*Comment Received From: Pool & Hot Tub Alliance and CA Swimming Pool Association
Submitted On: 9/7/2023
Docket Number: 22-BSTD-01*

PHTA CPSA Comments

Re: Proposed updates to the CA Energy Code related to pool and spa heating

Typical Solar collector plumbing kit available in market

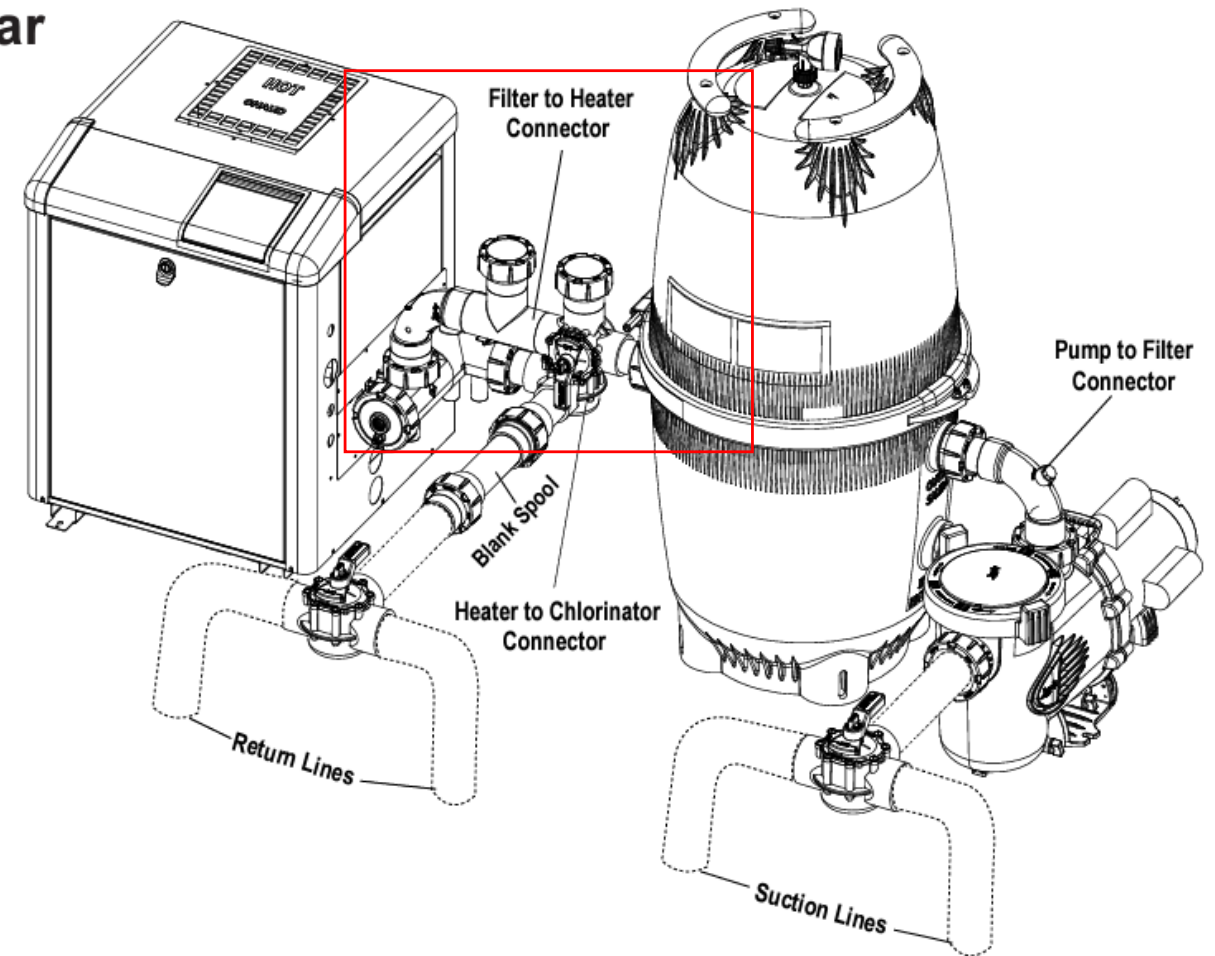
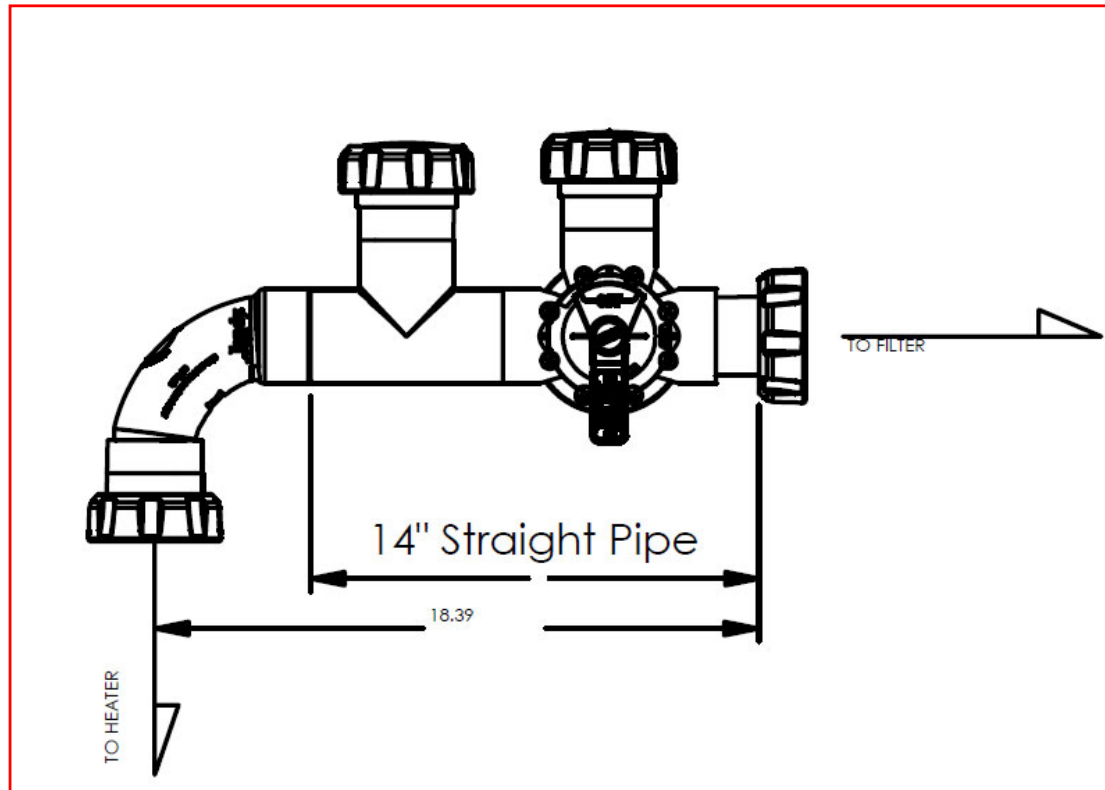
Reasoning: PHTA and CPSA urge the Commission to follow the ANSI/PHTA/ICC-15 Standard that has been adopted in countless states and local jurisdictions via adoption of either the International Energy & Conservation Code (IECC) or International Swimming Pool & Spa Code (ISPSC), or direct state code references such as the Florida Energy Code. This standard requires a minimum of 18 inches and although the standard applies to residential pools, there is no difference in commercial versus residential application when adding piping for the future installation of solar heating. Simply put, 18 inches is sufficient in either case.

The 18 inches of horizontal or vertical pipe is more than enough room to provide two Ls and a T with a valve. In addition, 36 inches could not work in some spaces, as there are cases where not enough room will exist on the pool pad or equipment room. In canvassing our members and solar representatives, no one has said 18 inches of pipe for a solar pool heating installation is not adequate. Please also see the drawing of a typical solar piping kit that is available on the market, along with a photo of an install using 2.5" plumbing (attached to submittal). These kits are available with all pre-cut components that then get assembled in the field, using the 18-inch minimum requirement. If these 18-inch kits were not adequate in some instances, installers would let kit manufacturers know. The fact is they do work and we encourage the Commission to align with what is both on the market and in national codes and standards.

- Jandy VPK-CVSLR
- Accommodates 2" and 2-1/2" plumbing.
- 14" Straight pipe requirement

Installed Solar Plumbing Kit Using 2-1/2" Pipe

- (b)2. Piping.** At least ~~18~~³⁶ inches of horizontal or vertical pipe shall be installed between the filter and the heater or dedicated suction and return lines, or built-in or
